From: Ross Nettle <ttpa@ttpa.com.au>
Sent: Monday, 21 November 2011 4:04 PM
To: Alexis Cella
Subject: Ref 10178 - Discovery Point Stage 1
Attachments: sp 17 11 11 12.5BUS.pdf; DOC211111.pdf

The following statement addresses outstanding issues in relation to “transport and traffic”.

Linc
Discovery Point, Walli Creek
Permanent & Temporary Bus Stops

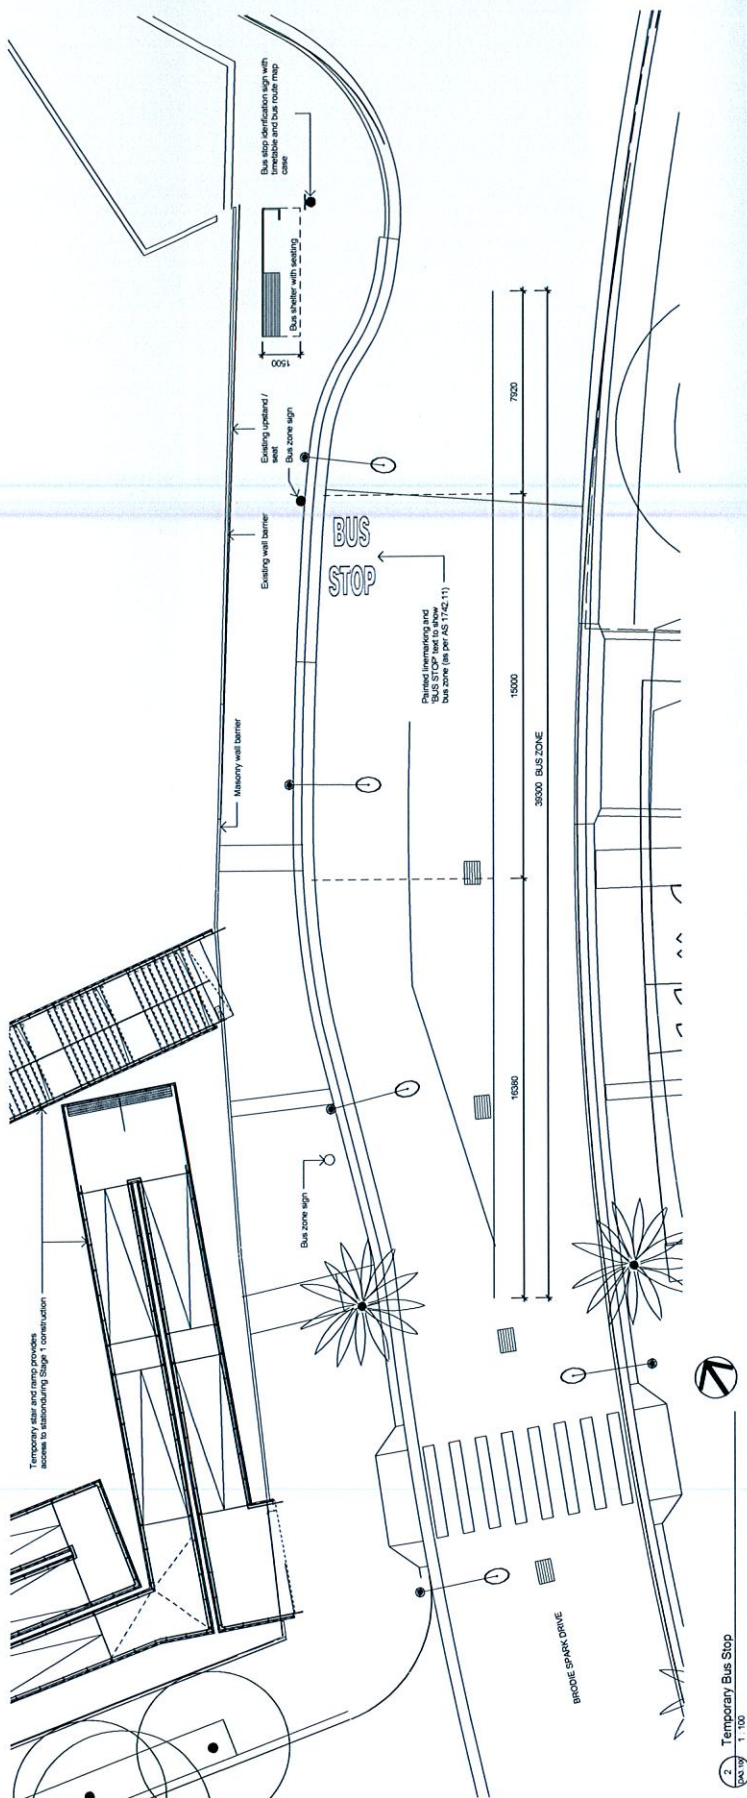
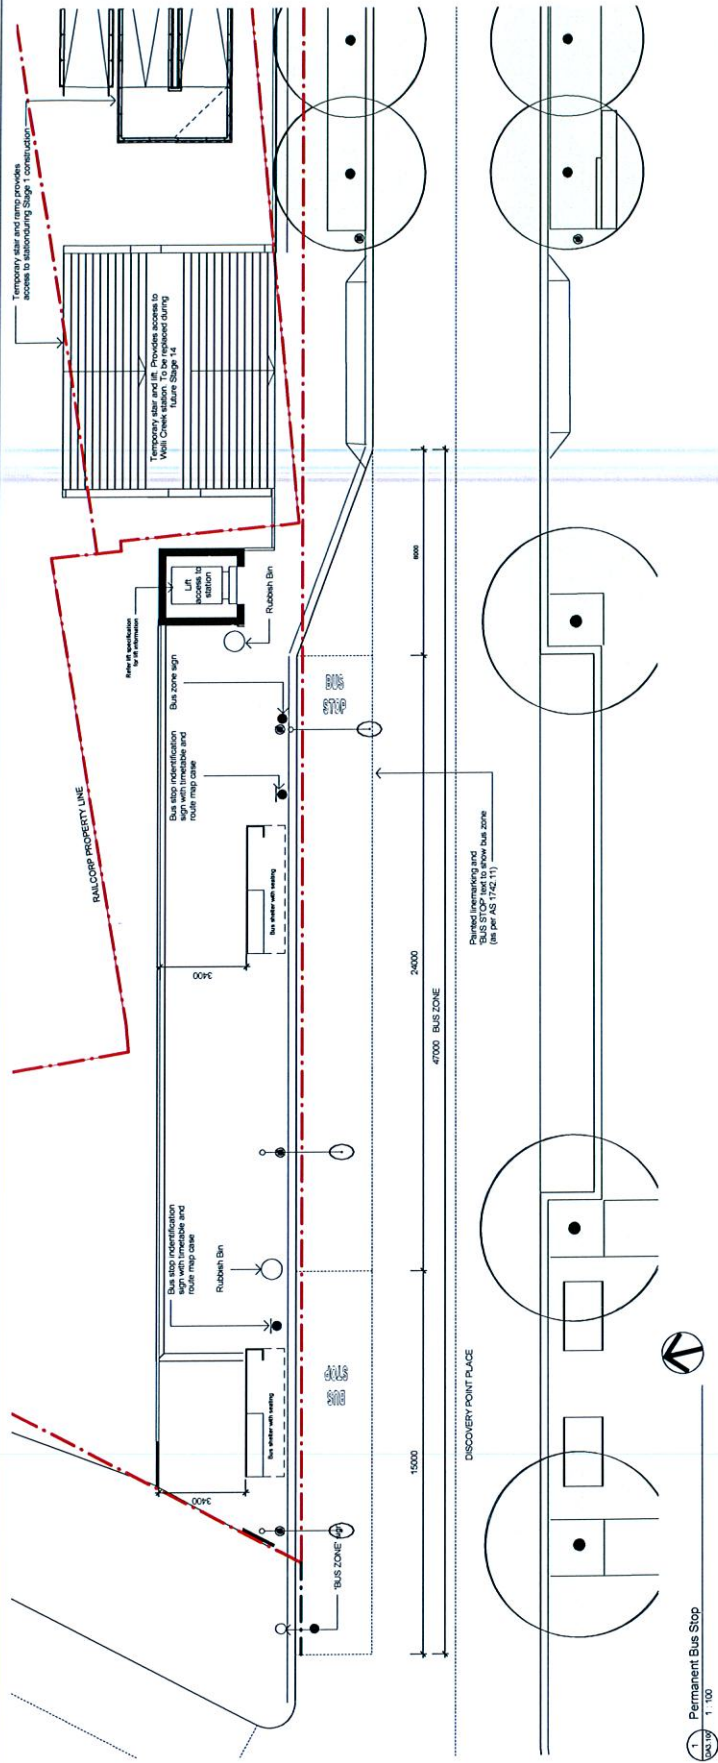
STA has formally advised their concurrence to the permanent and temporary arrangements and provisions for buses. Copy of email response is attached.

Thank you for forwarding the documents for review. State Transit has no objections to the proposed temporary arrangements and the final arrangements. It would be appreciated if you could advise of a proposed commencement date so we can advise our operational staff and customers of the change in route.

SWEPT PATH ANALYSIS OF A 12.5m BUS

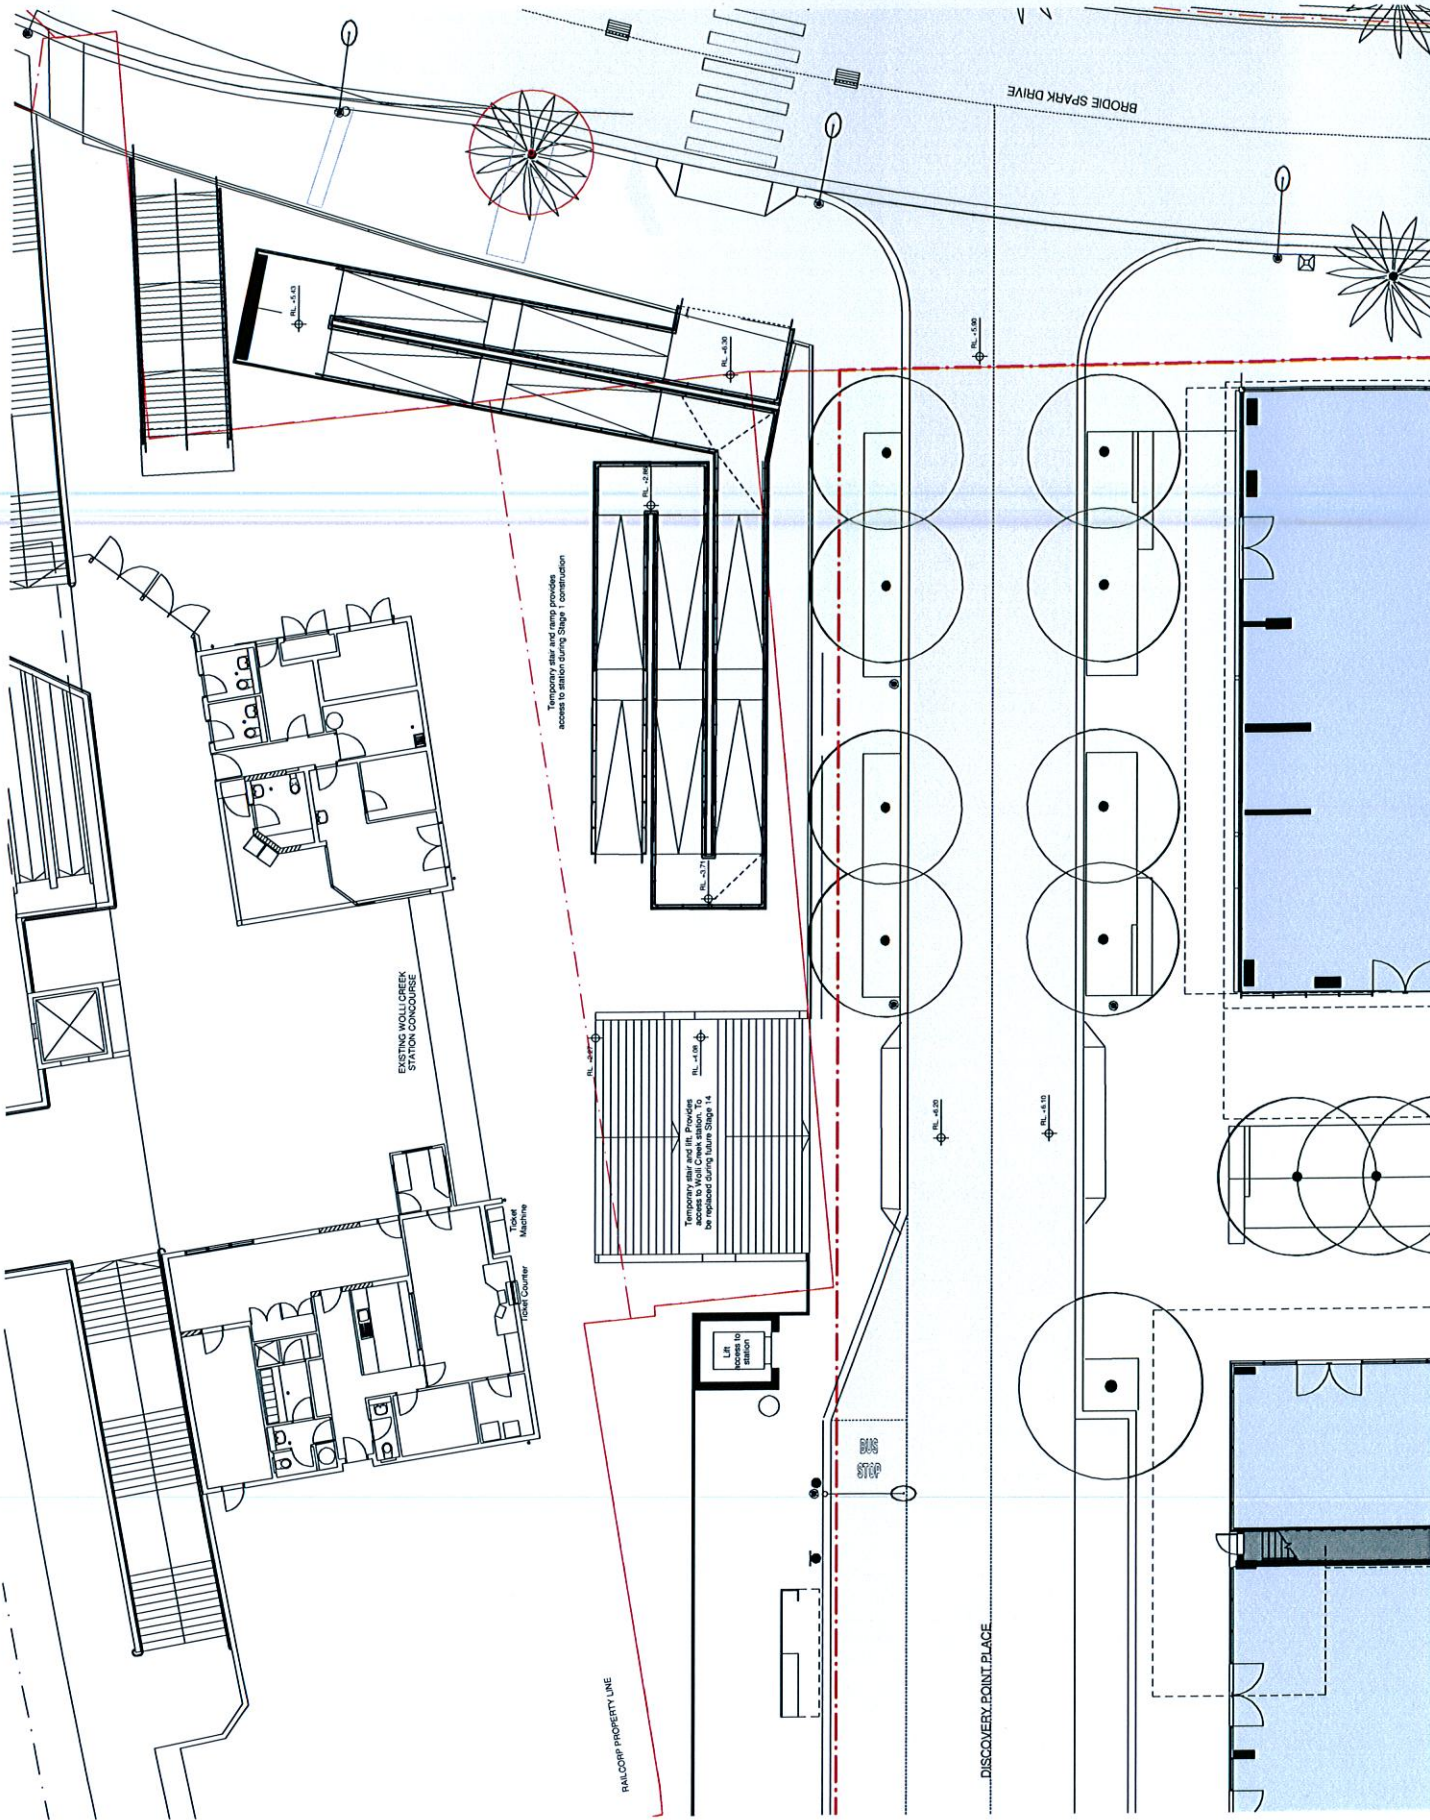
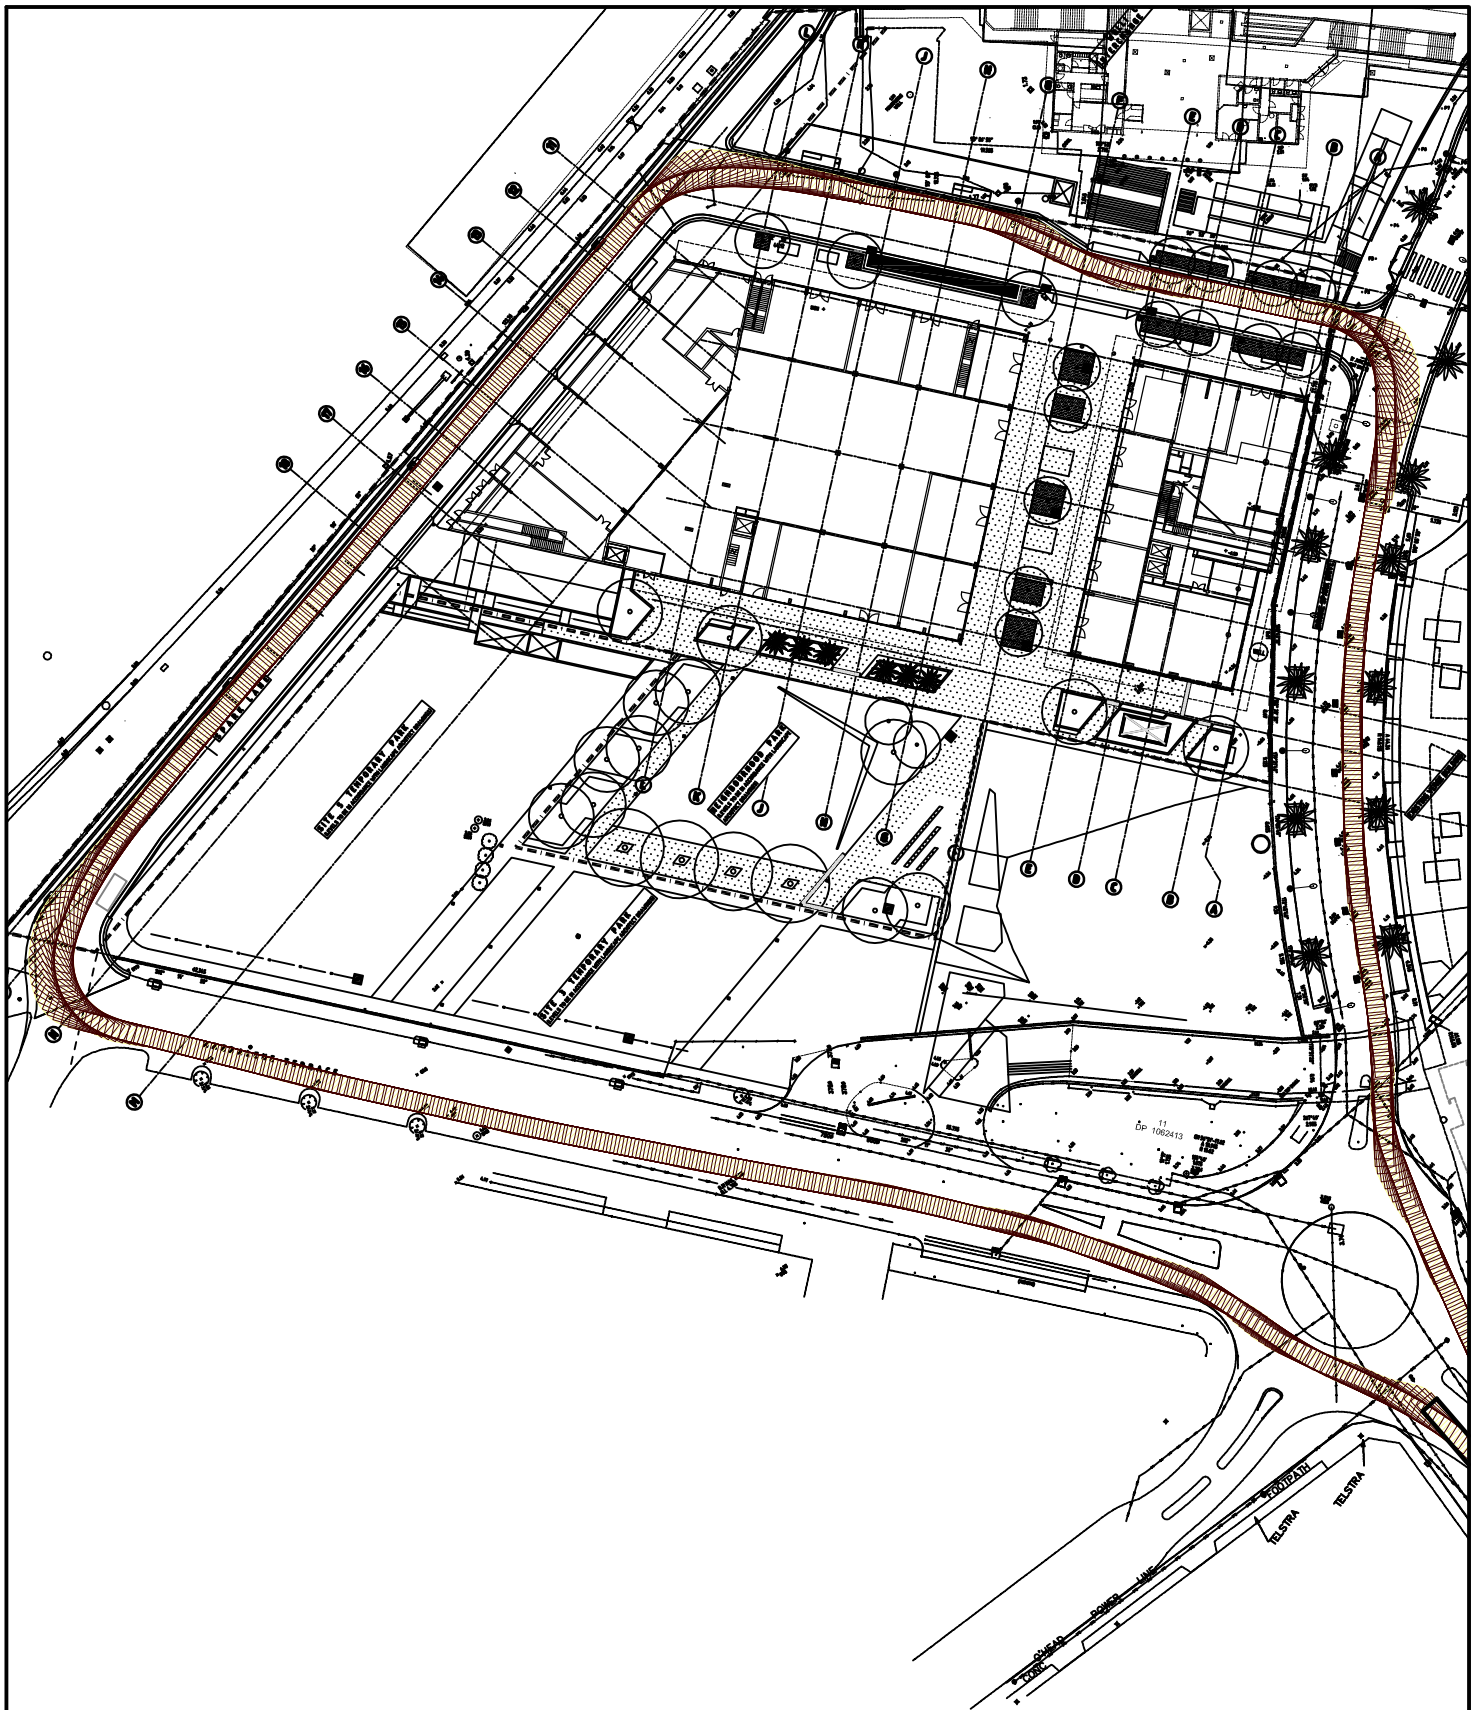
The attached turning path diagram confirms that arrangements at this intersection are suitable for buses and for clarity of intersection control

The attached turning path diagram confirms the 12.5m buses will be suitably accommodated on the road system.
